NEW Fristam FPR 857/858 Coil Spring Seal

Fristam has developed an alternative FPR centrifugal pump seal for those who prefer the FP/FPX coil spring style seal.

Rotating seal (at right, colored components)

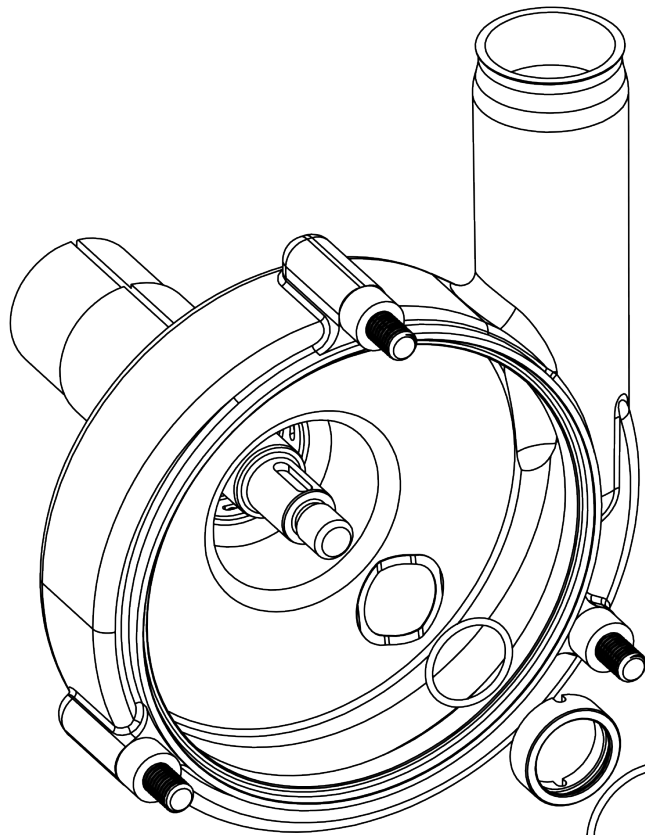
- coil spring (green) instead of wave spring
- metal washer (yellow) added to protect the rotating seal o-ring (blue)
- inner seal driver o-ring (orange, small) sits in a channel in the seal driver (purple) instead of halfway down the extended back end of the original driver

- dimensions have changed but not function

- no changes
